Re: *Addendum No. 1*
Parkwood Drive & Kerry Lane Waterline and Pavement Improvements
OPWC Funded Project No. CG44AC / CG45AC

City of Wickliffe

Date: September 9, 2025

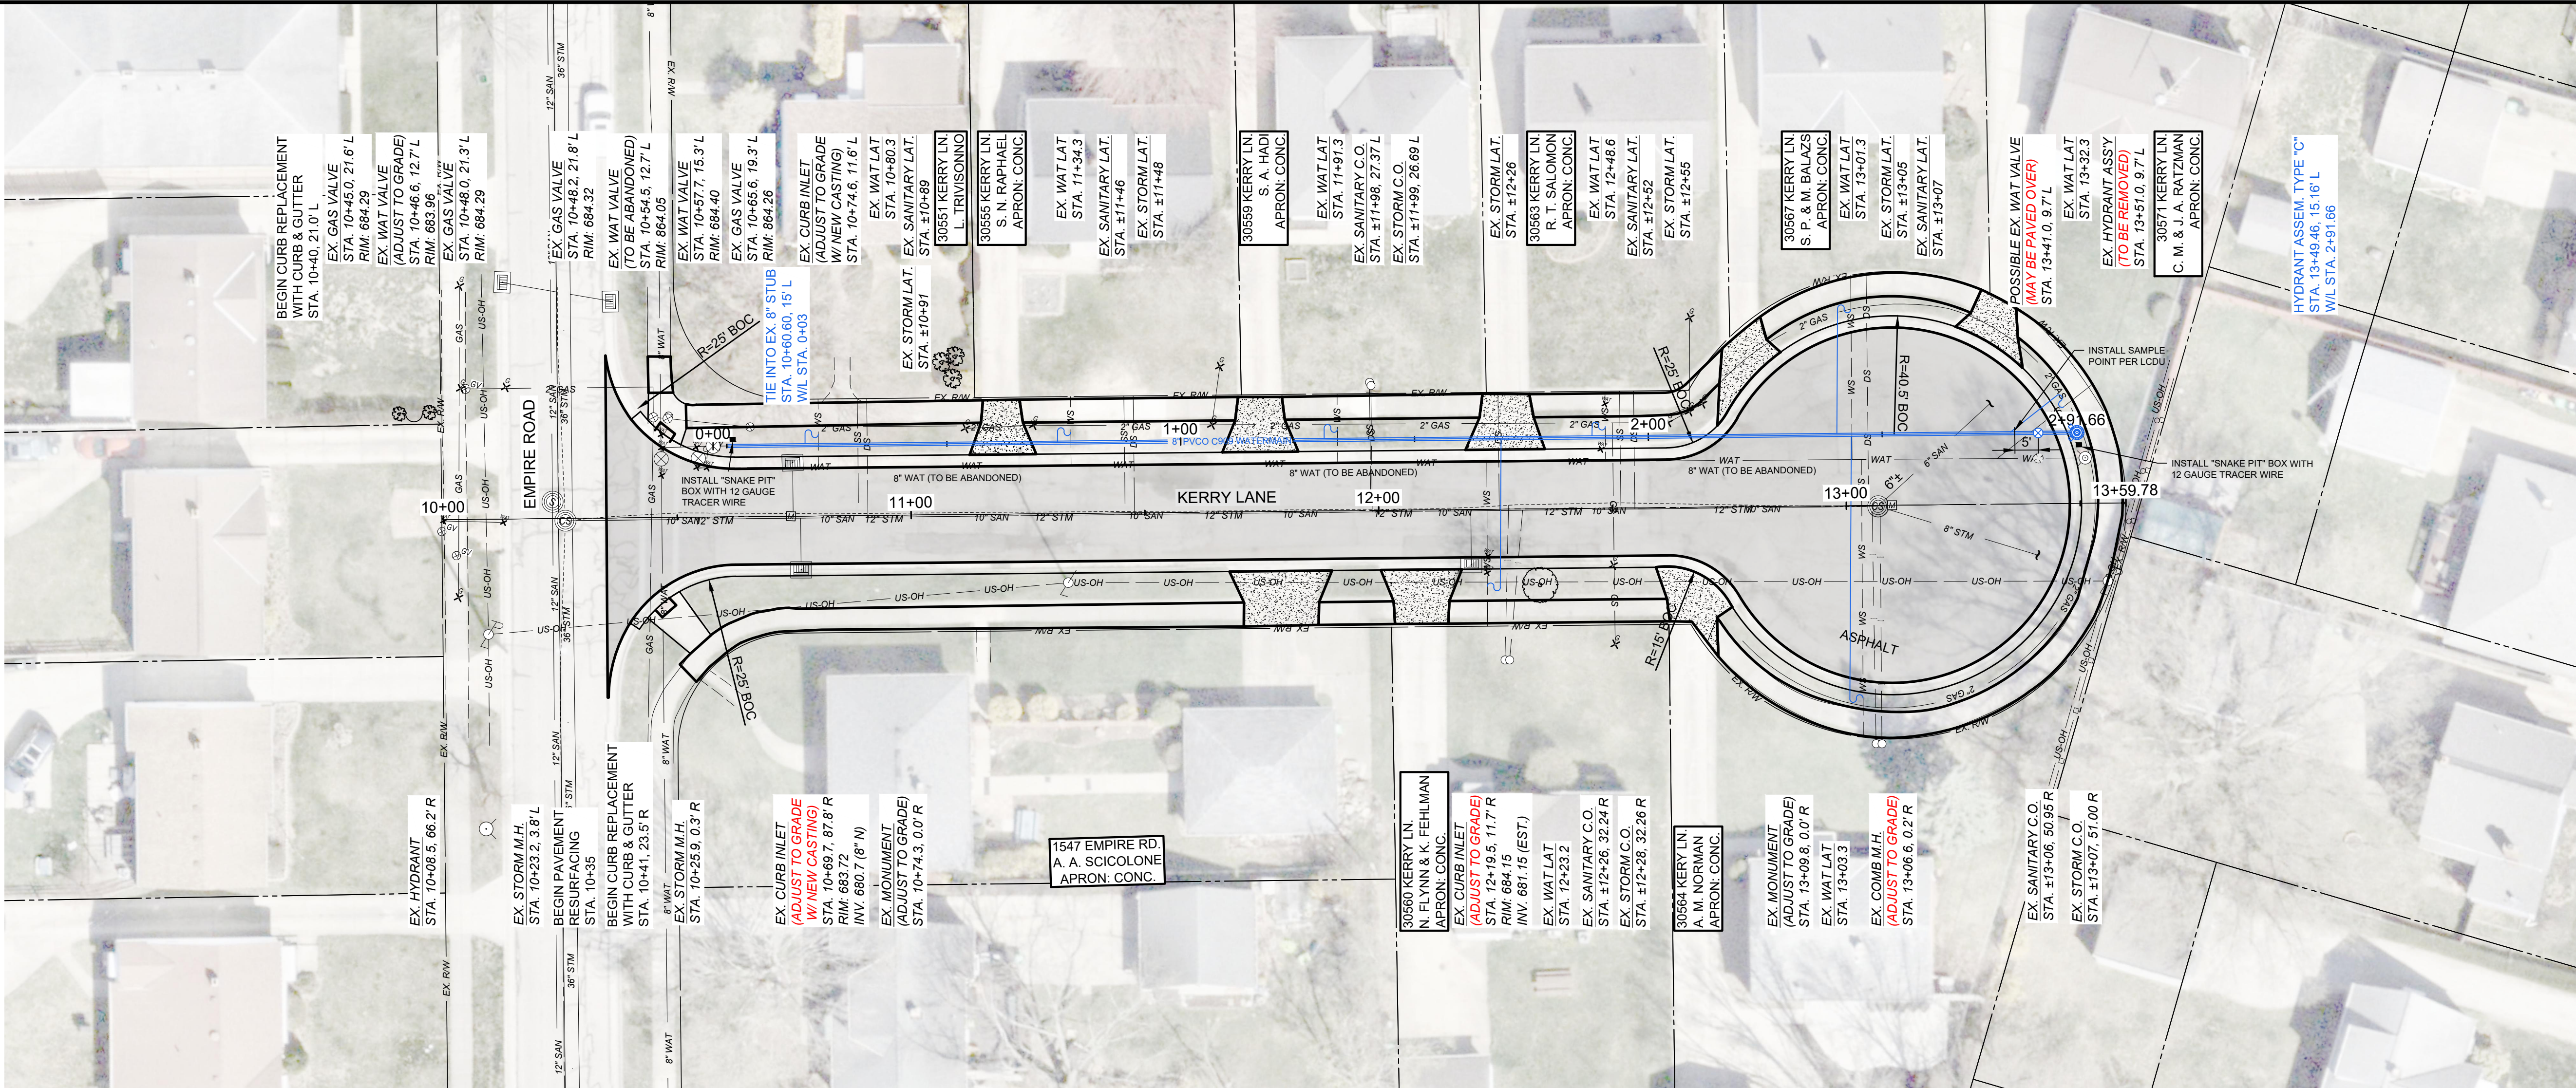
NO		REVISION	DATE	<div>CITY OF WICKLIFFE</div> <div>PARKWOOD DRIVE & KERRY LANE WATERMAIN AND PAVEMENT IMPROVEMENTS</div> <div>LAKE COUNTY, OHIO</div>	ISSUED FOR: DRAFT		<div>GENERAL NOTES</div>	PROJECT NO.		
	1		ADDENDUM - PER LAKE COUNTY DEPARTMENT OF UTILITIES COMMENTS	9/3/2025		ISSUE DATE: 9/9/2025			32252		
						SCALE: AS SHOWN			DISCIPLINE		
						DESIGNED BY: PJF			CIVIL		
						DRAWN BY: CKW			SHEET NAME		
						CHECKED BY: PJF			GN-1		
									SHEET	OF	
									2A	18

PROJECT NO.	32252
DISCIPLINE	CIVIL
SHEET NAME	Plan P1
SHEET	OF
7A	18

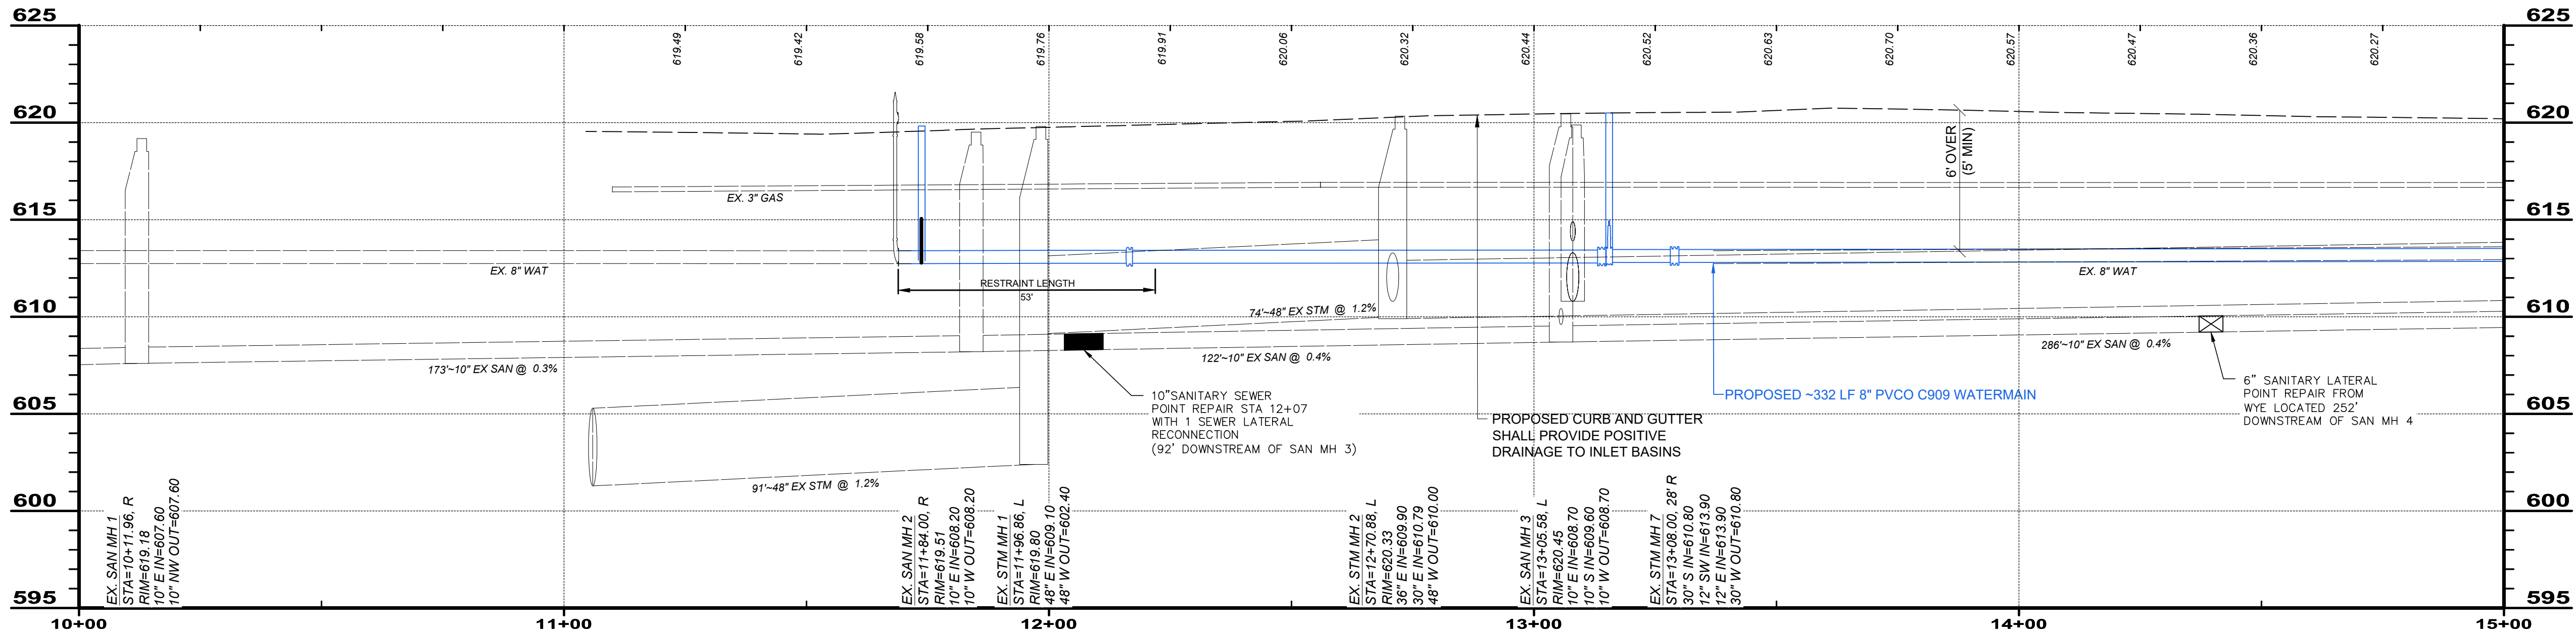
LCDU SEQUENCE OF CONSTRUCTION SHALL INCLUDE FLUSH FROM BRYN MAWR FOR PARKWOOD

PROJECT NO.	
32252	
DISCIPLINE	
CIVIL	
SHEET NAME	
Plan P2	
SHEET	OF
8A	18

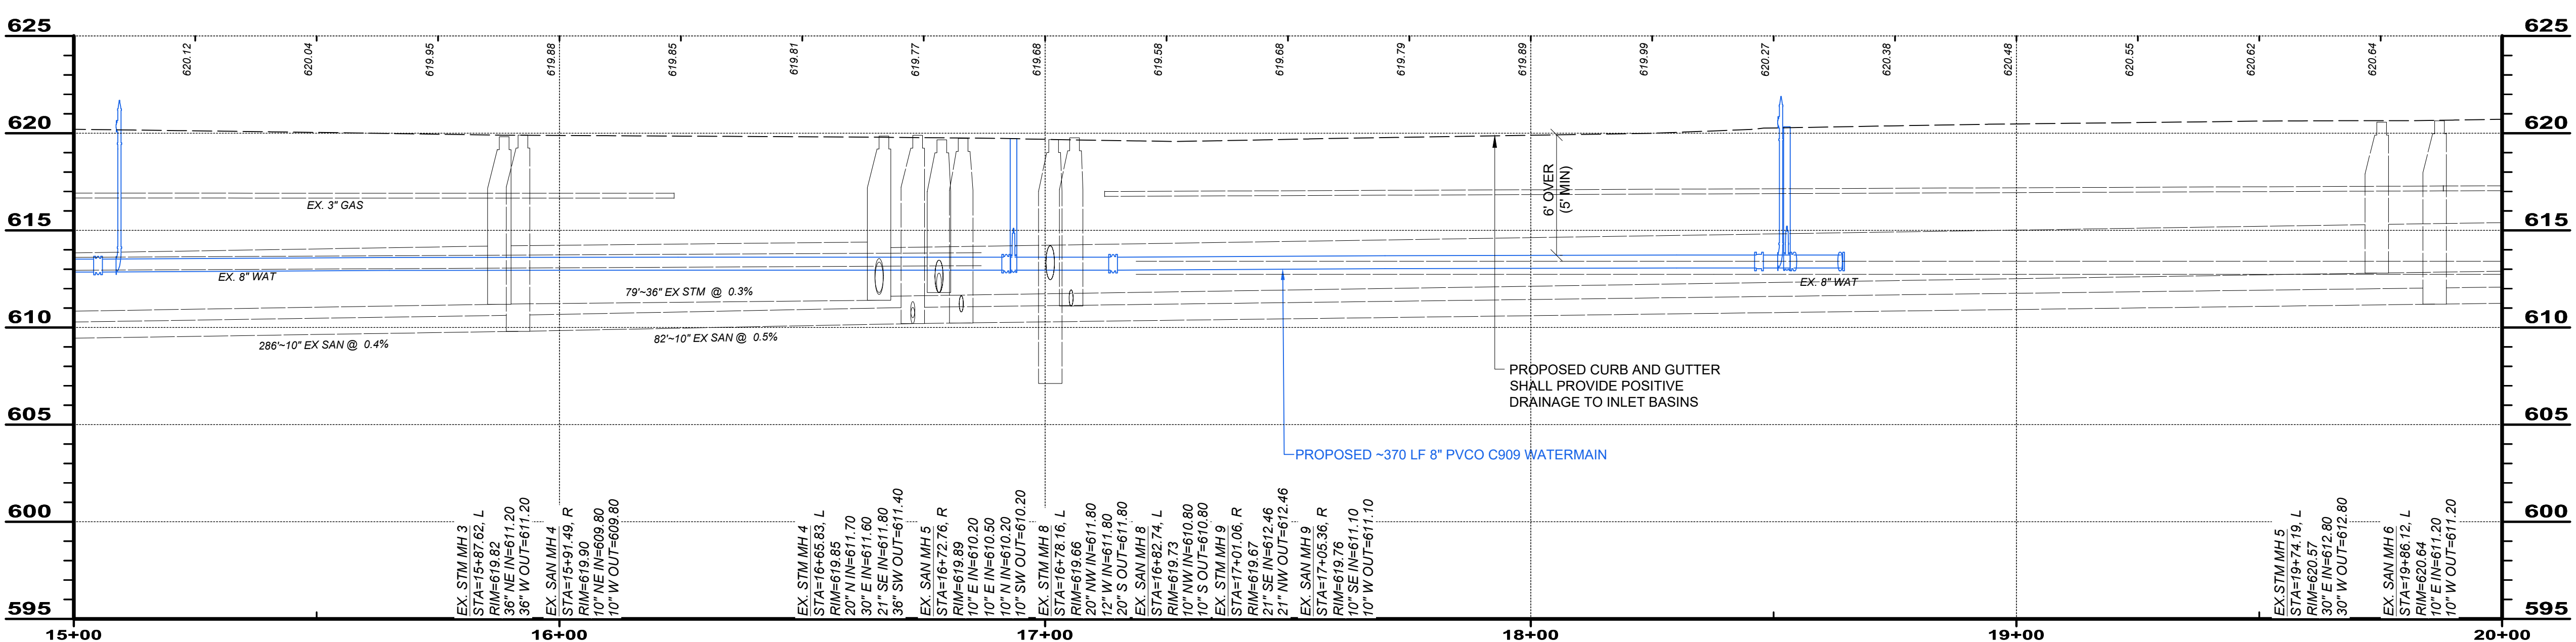
LCDU SEQUENCE OF CONSTRUCTION: BUILD THE WATERMAIN TO THE BEND AT STA. 18+34, 18' RT. TEST THE MAIN THEN MAKE THE CONNECTION TO THE EXISTING MAIN.
